# AGENDA – Planning Commission Meeting

## Planning Commission Staff Report

### Major Community Plan Amendment Wildflower Thursday, March 25, 2021 Public Meeting

# Conceptual Open Space Dedication Exhibit

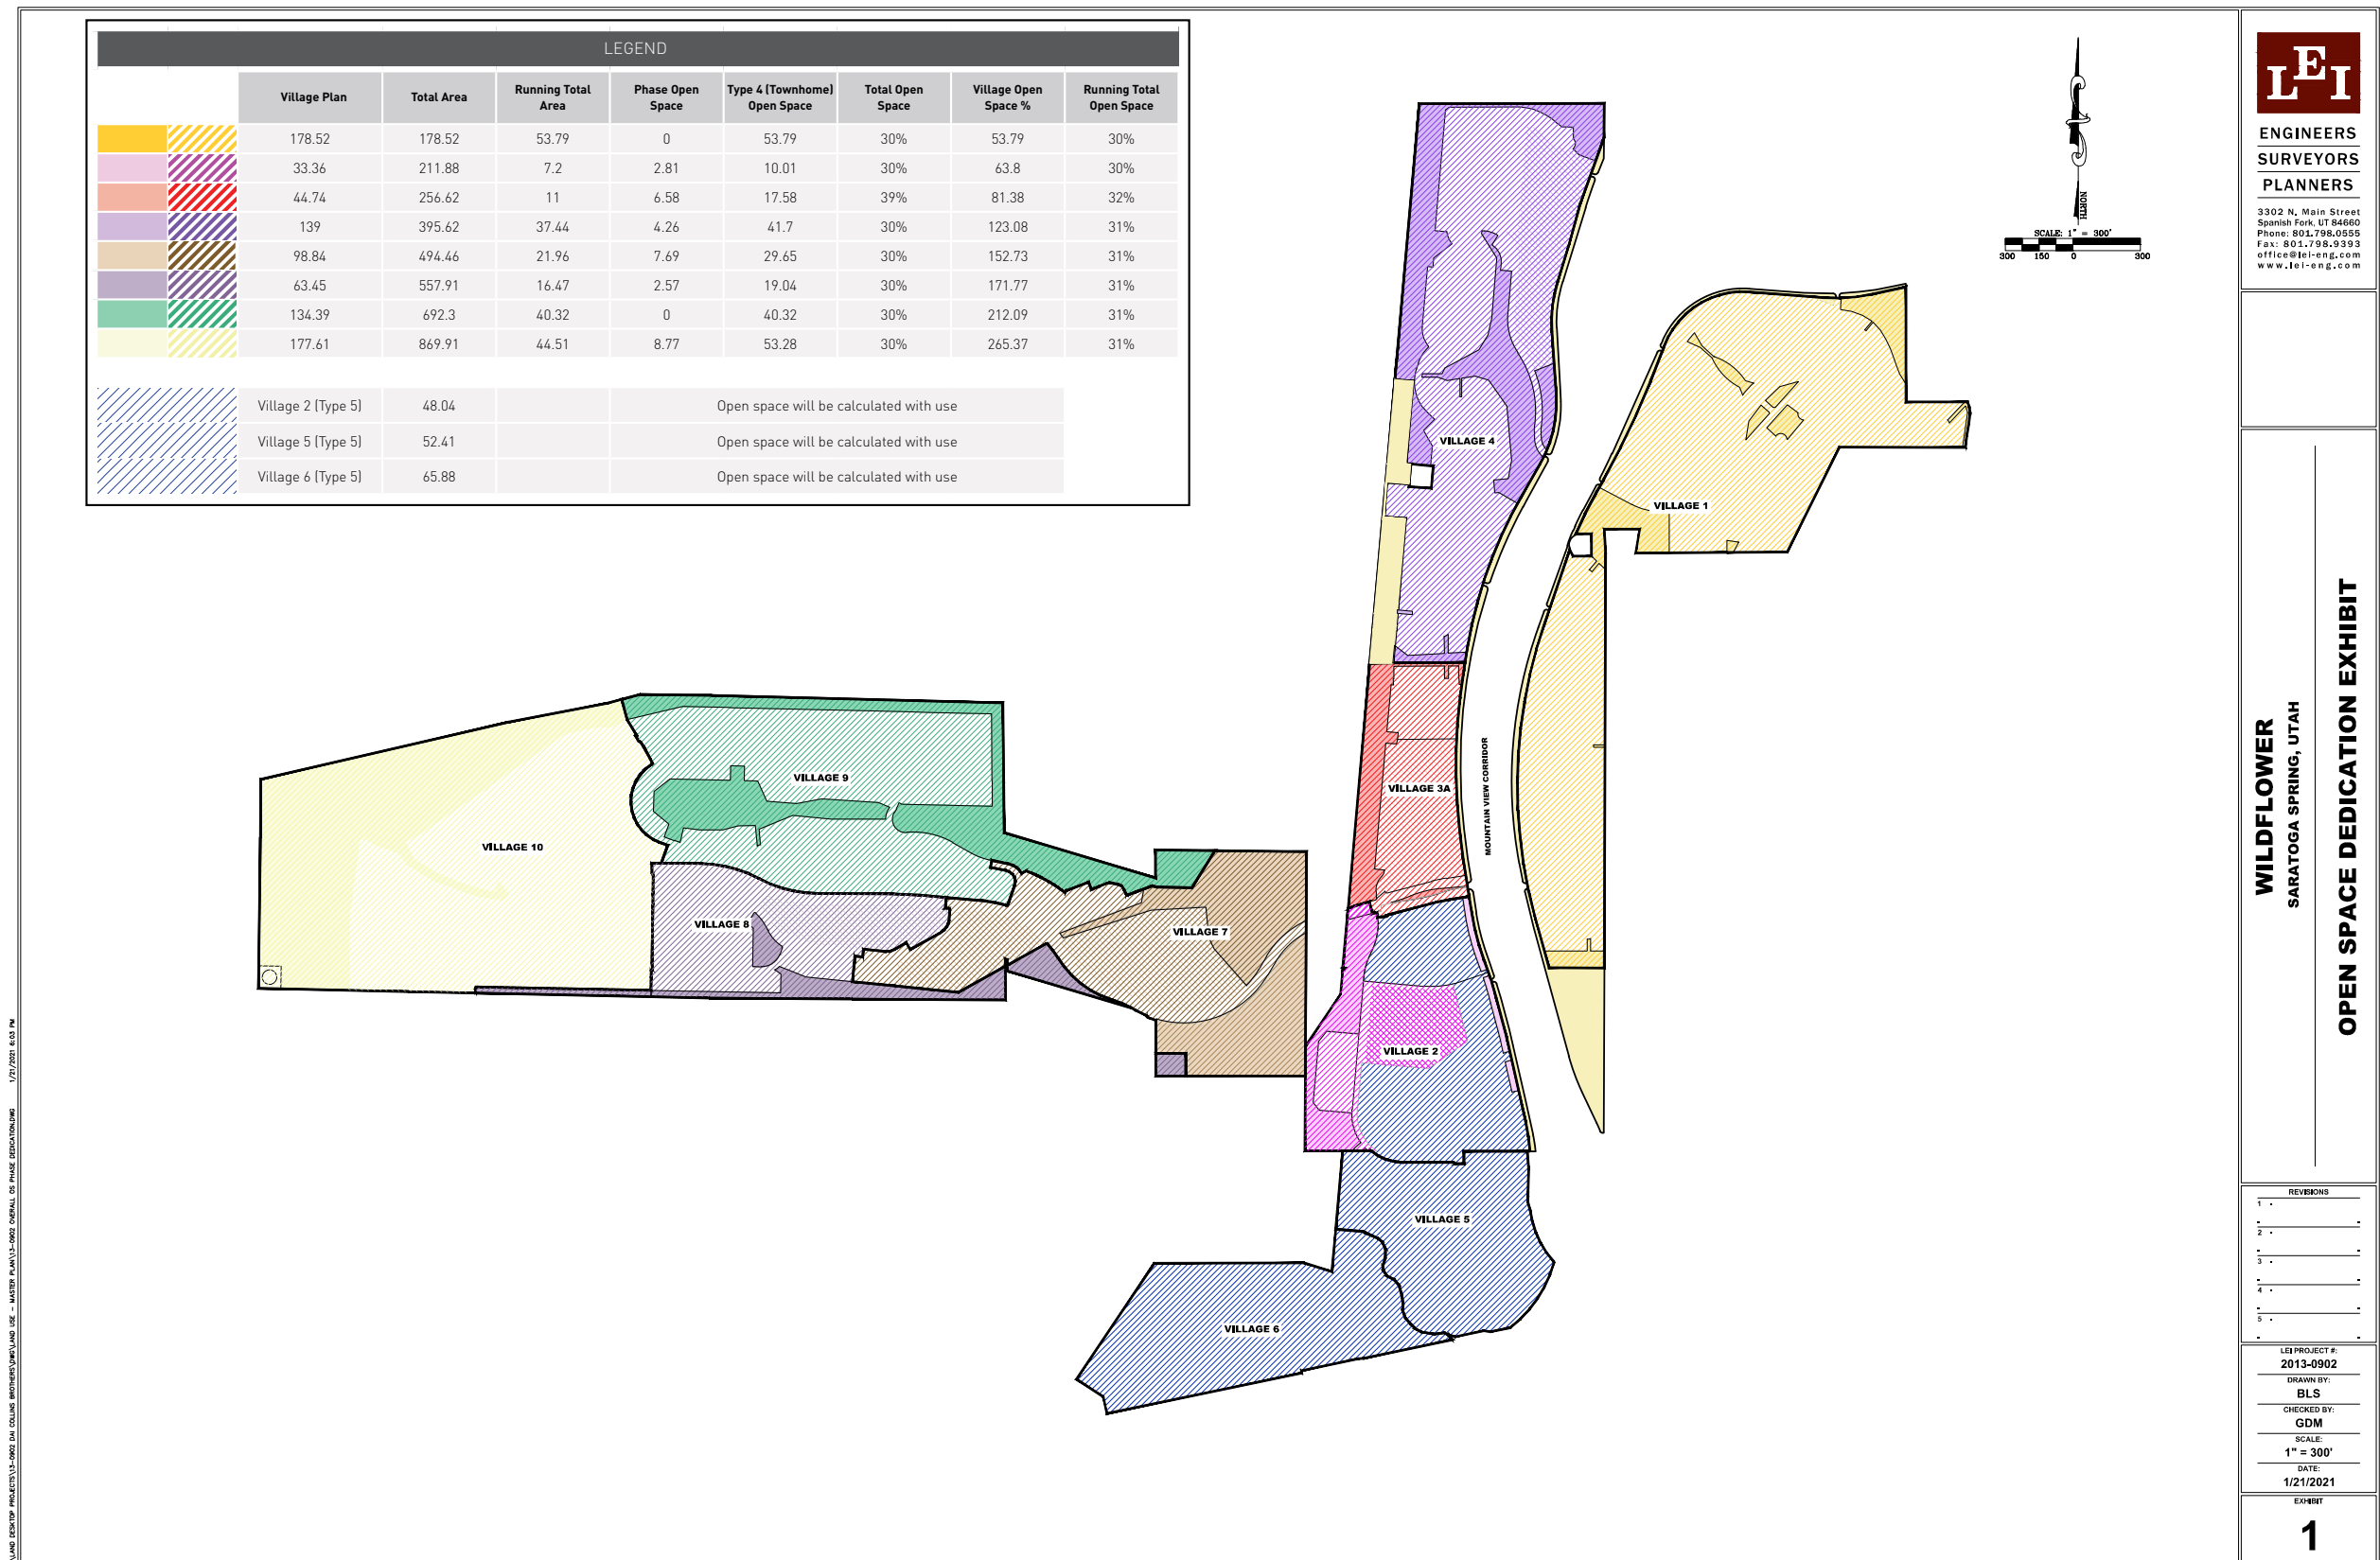
Staff also recommends that the applicant show conceptual open space trail connections through the larger parks that were removed in the Community Open Space Exhibit on Page 4-13 and the Community Trail Exhibit on Page 4-20. This exhibit is already conceptual, and trail connections are important to the usability of the open space areas.

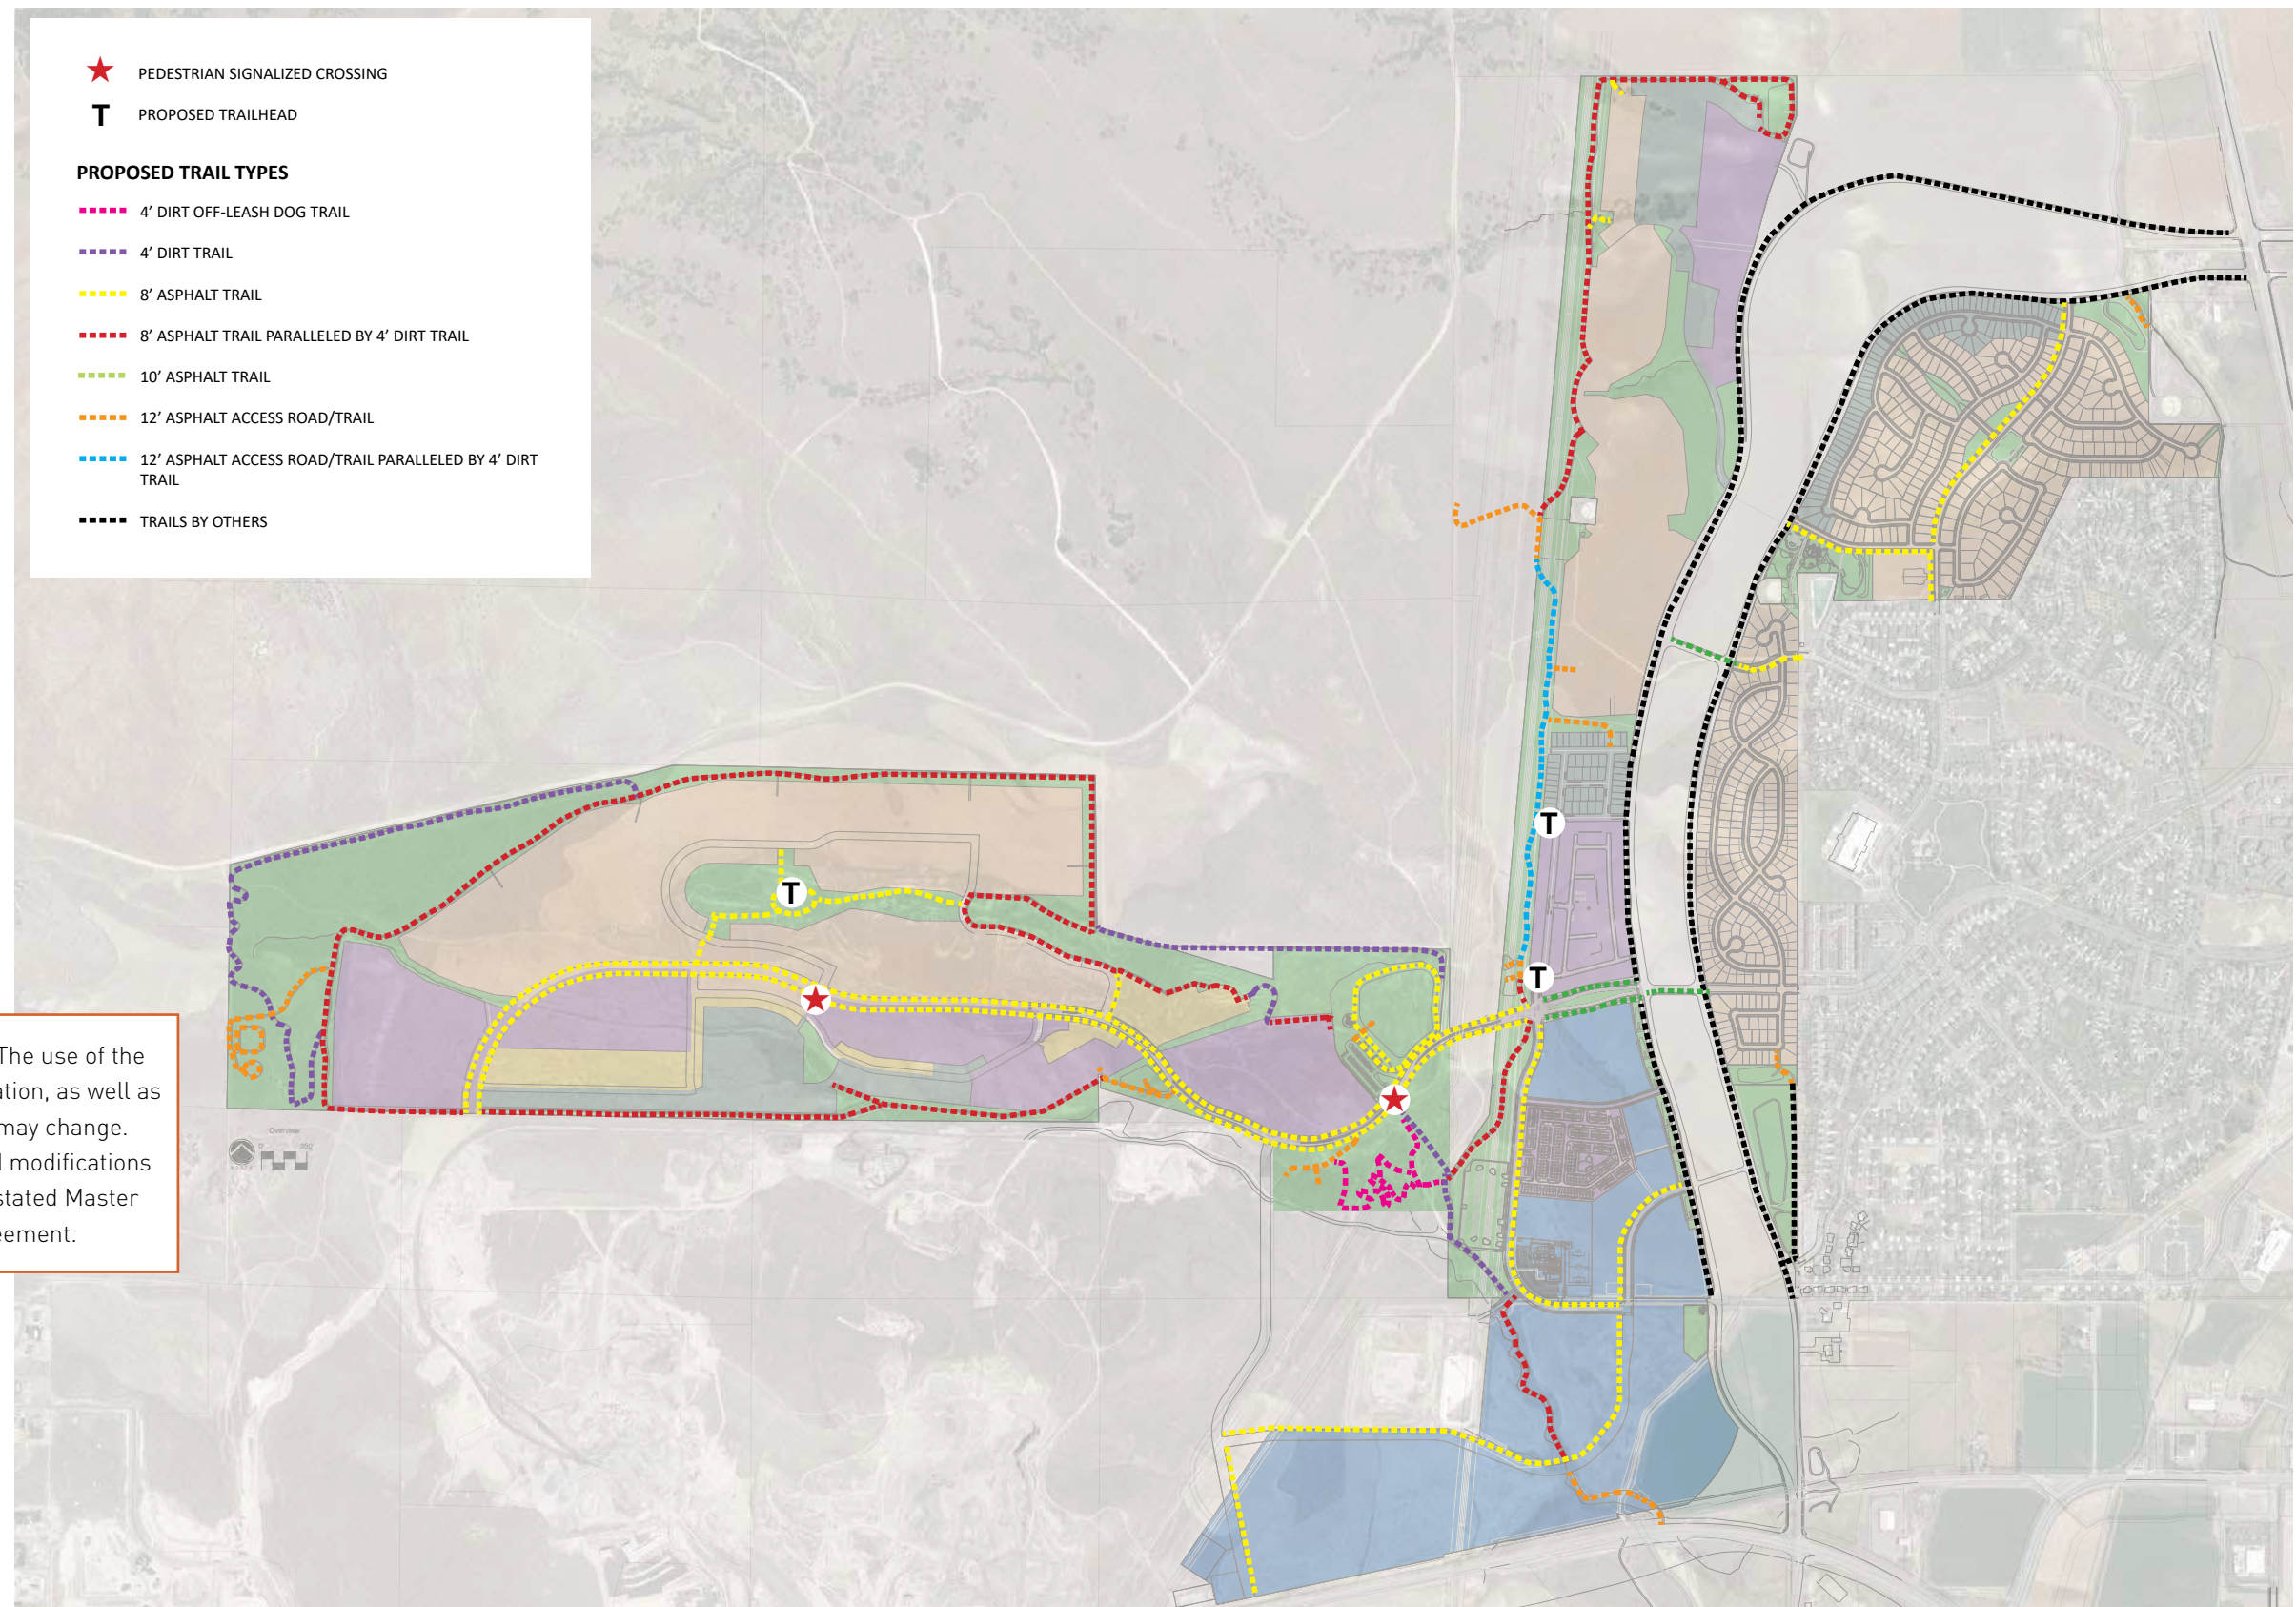
Additionally, staff is recommending that the applicant identify a minimum standard for Type 4 (multi-family) open space. The Community Plan only states "Future internal open space to be determined," however, this vague language has made it difficult to determine what is appropriate for the number of residents living in these areas, particularly in terms of amenities. Staff has added a condition of approval that the applicant work with staff to propose a minimum standard, even if the individual Village Plans meet overall open space and landscaping requirements.
